- Changes and errors:
1. The J11 input ground selection jumper is not useful.
 2. The footprint for U13 is incorrect on the PCB
 3. Selection for ATXU13 should be via zero ohm resistors
 4. 500 pF caps should be added to all RF inputs and outputs
 5. HELA 10 amplifiers are added with solder mask on PCB
 6. Remove L16 and C79
 7. Need test points on the band pass filter to facilitate tuning
 8. Add a block on PCB to write what the attenuator settings are

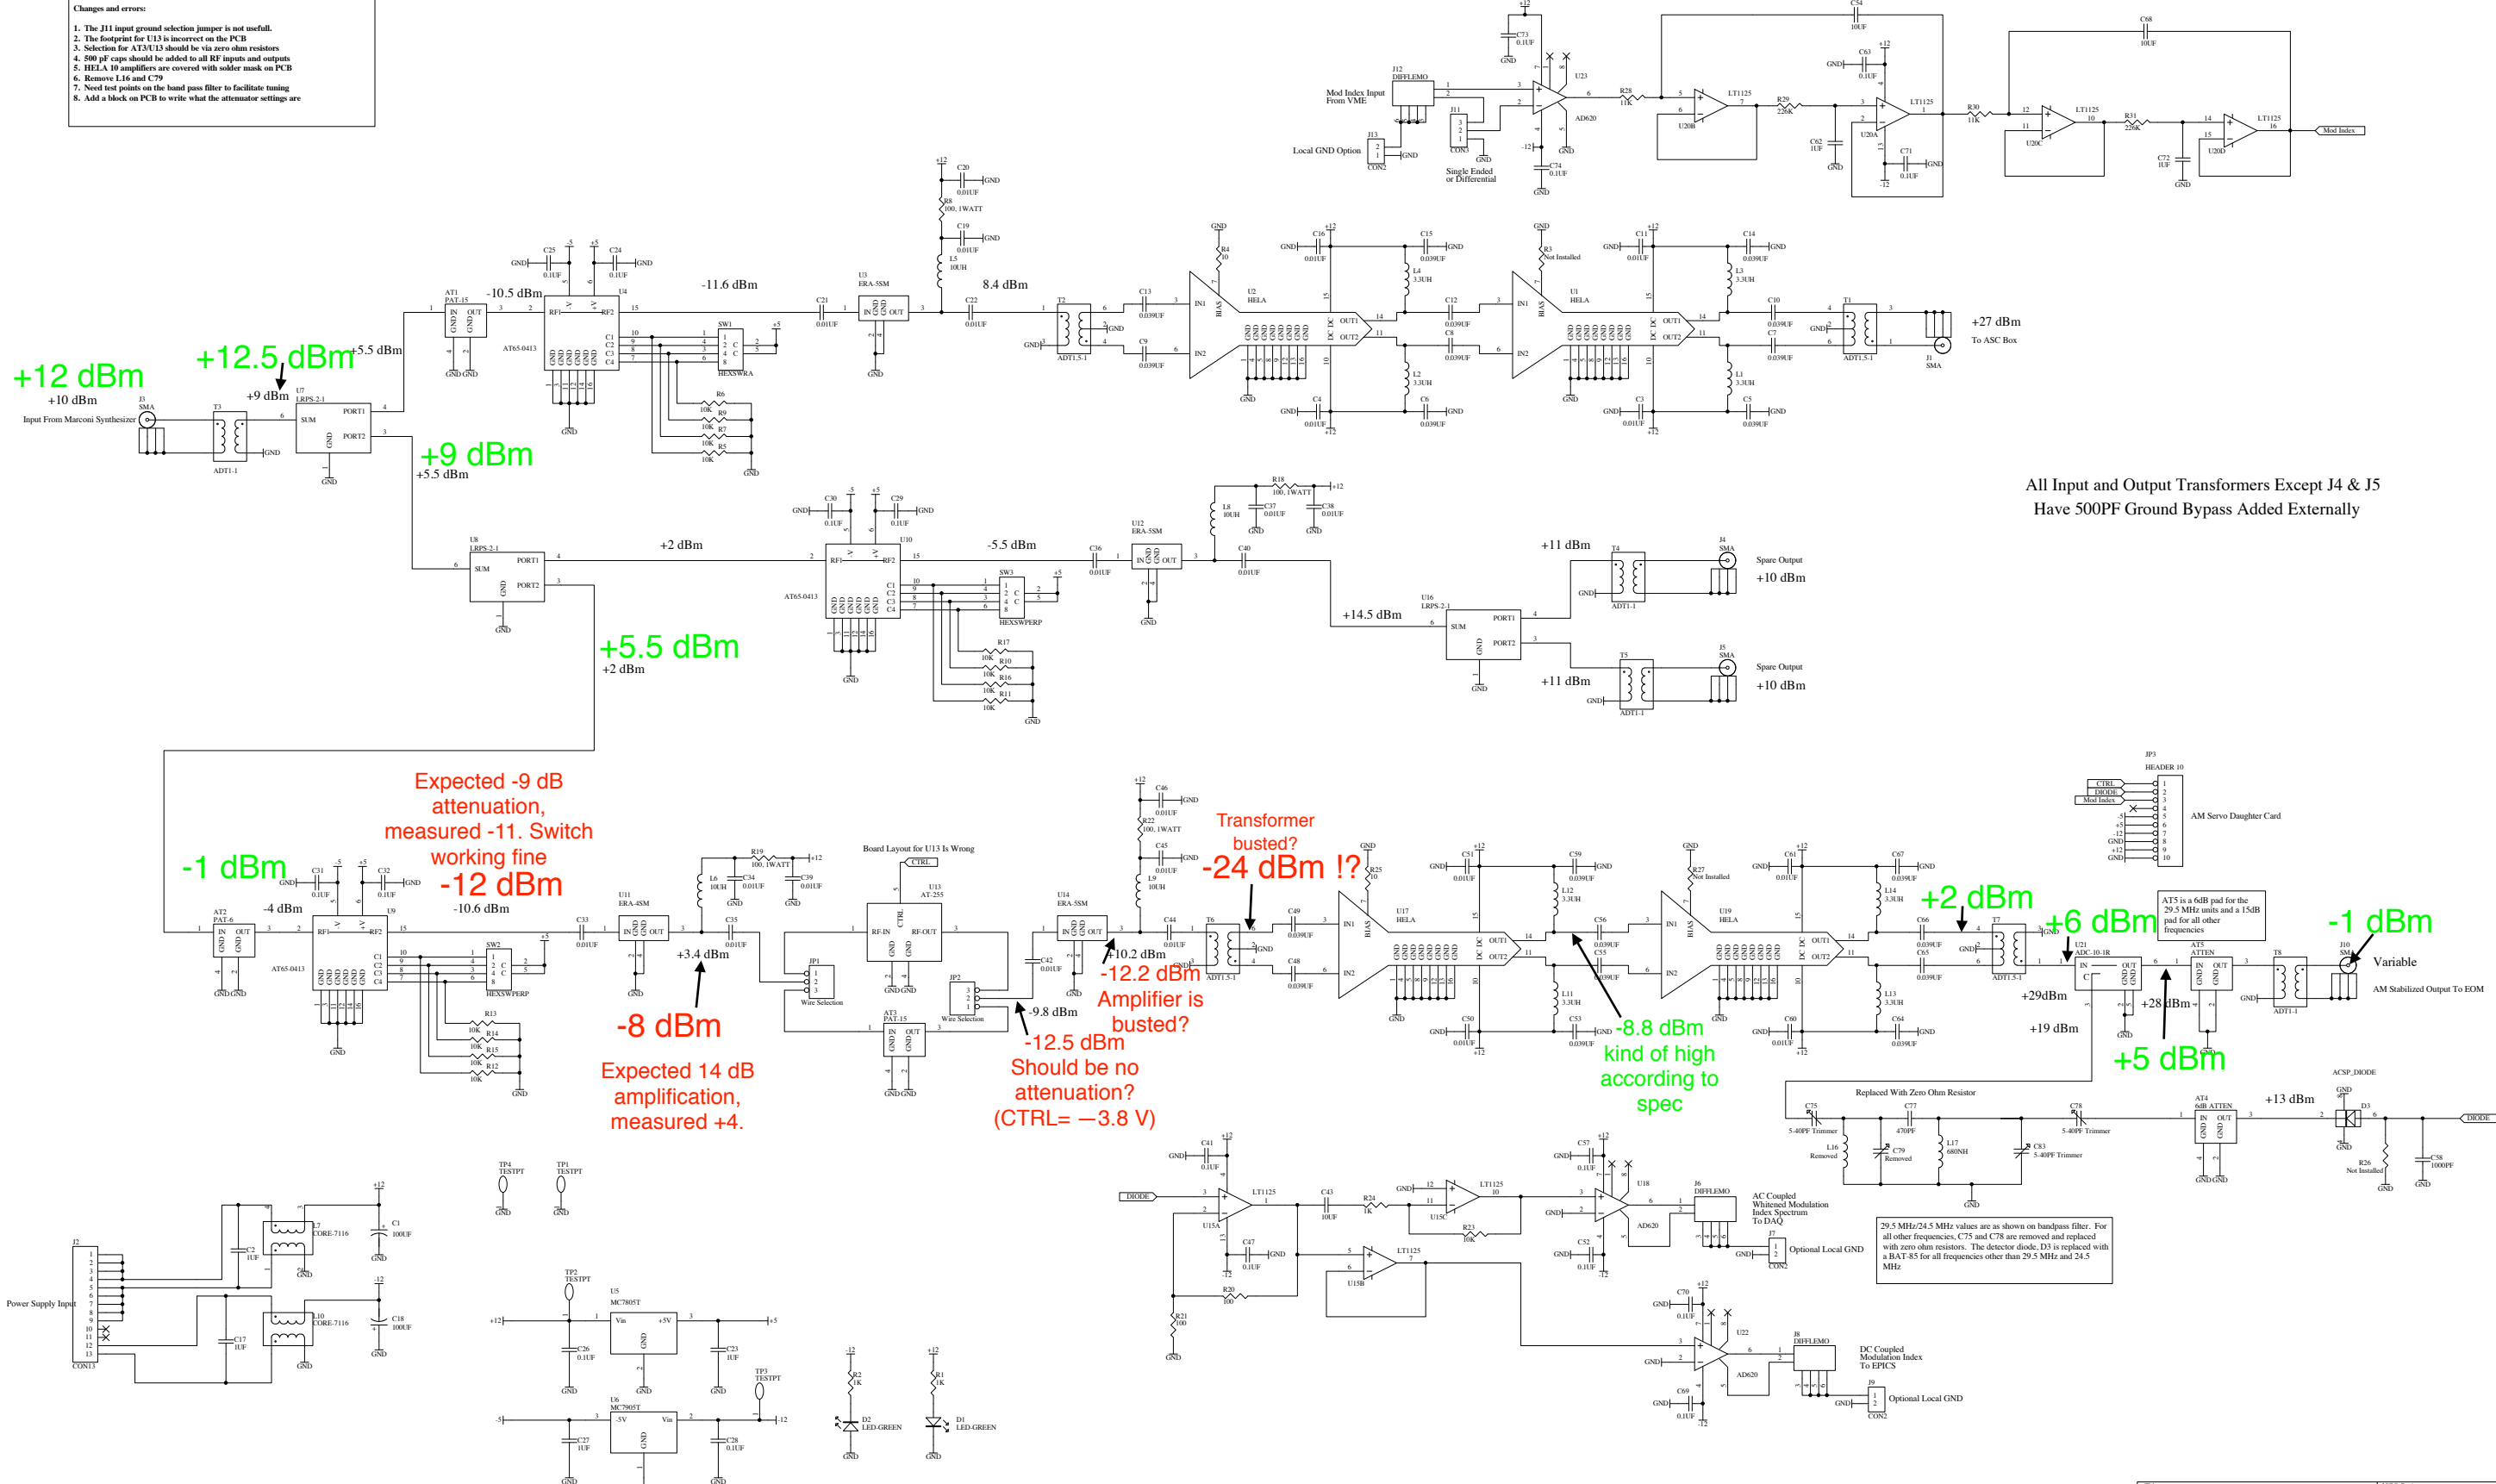
All Input and Output Transformers Except J4 & J5
Have 500PF Ground Bypass Added Externally
